# CORRIGENDUM DUE TO PRE-BID CLARIFICATION

Corrigendum No. 02 Dtd 25.09.2023

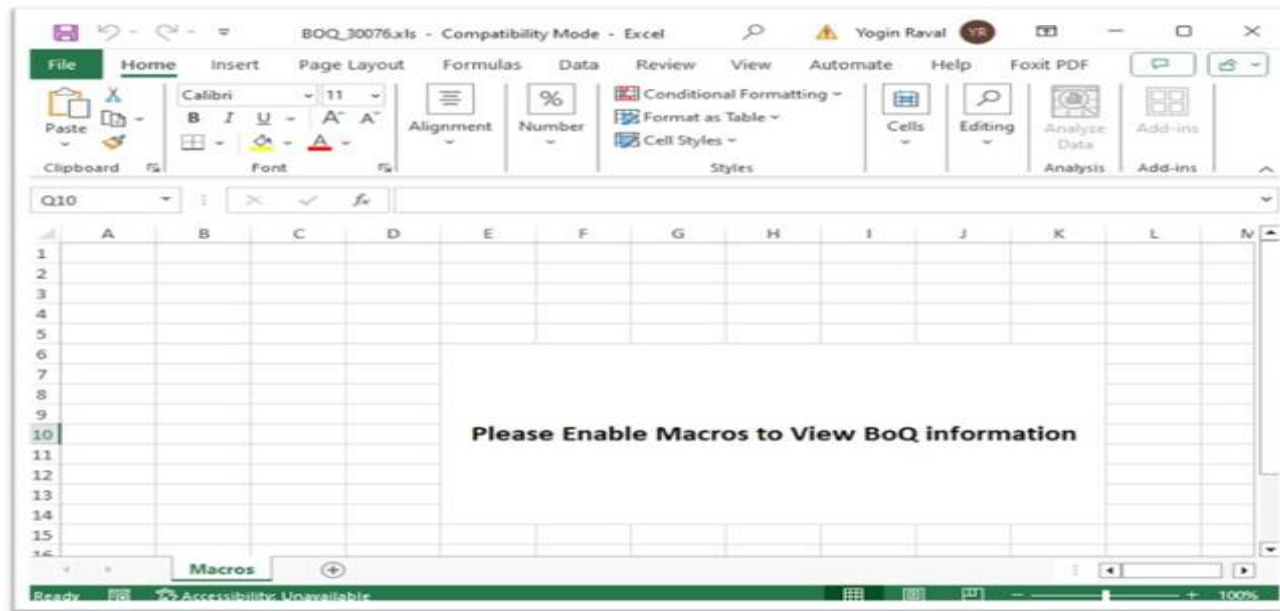
3. Your reply vide trailing email sr. no. G in regard to **MATCHING FLANGE** is not clear !

Kindly note that STAND POST will have one 100 mm flange inlet and two 80 mm flanged outlets,

As per the requirement Two Hydrant Landing Valve shall also have 80 mm inlet connection flange type, these two Valves shall be supplied with Stand Post duly fitted as complete assembly hence matching flange is not required for 80 mm connection. If required, matching flange may be for 100 mm inlet connection of stand post ! so please confirm  
One number Ms - Matching Flange 100 mm is to be supplied, else please advise.

**80mm flanged outlets required at hydrant post outlet as mentioned below. Accepted**

**The hydrant post & valves are to be sent in assembled condition. Yes. However, we still need the flanges at hydrant post outlet 80NB (3") and valve inlet 80NB(3") which are to be**

<b>used for connection. Flanges to be an inherent part of the hydrant Post and valves.</b>
<b>4</b>	Your reply vide trailing email sr. no. H in regard to <b>ORIFICE PLAT</b> ! it is not required for connection of Fire Delivery Hose hence Orifice Plat is not required to consider, please confirm	<b>Confirmed not part of scope.</b>  <b>Any fitting for the Fire hoses to hydrant valves outlet connection is to be considered part of scope by vendor and to be supplied</b>
